Council Reference: DA17/0498 LN11041
Your Reference:

Development Application for a shop top housing, serviced apartments, swimming pool and demolition of existing structures at Lot 1 DP 169524; No. 26 Marine Parade KINGSCLIFF NSW 2487

Figure 2: Extract of shadow diagram for proposed development

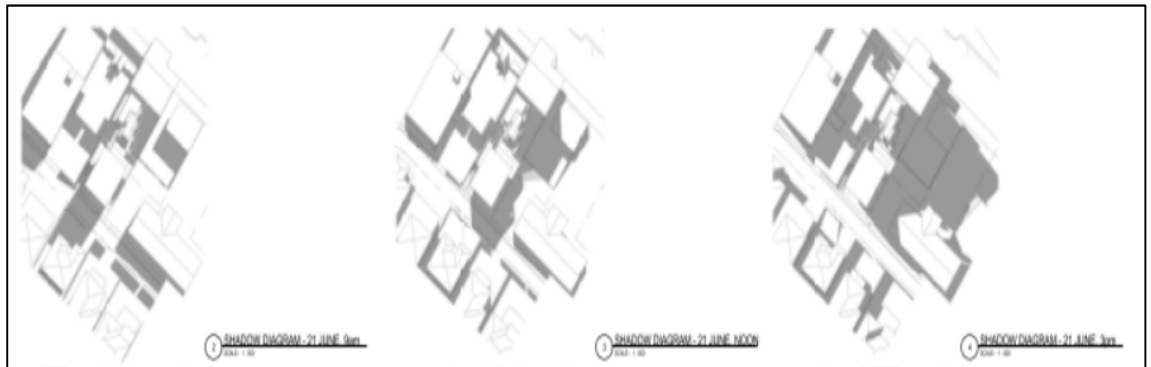
- iii. Based on the information provided, concerns are raised over solar penetration to principal private open space areas associated with the residential component of the development. The submitted shadow diagrams demonstrate

that no part of the principal private open space areas and open garden area identified on the architectural plans will receive sunlight between 9am – 3pm on 21 June. You are therefore required to address this matter as part of any amended plans.
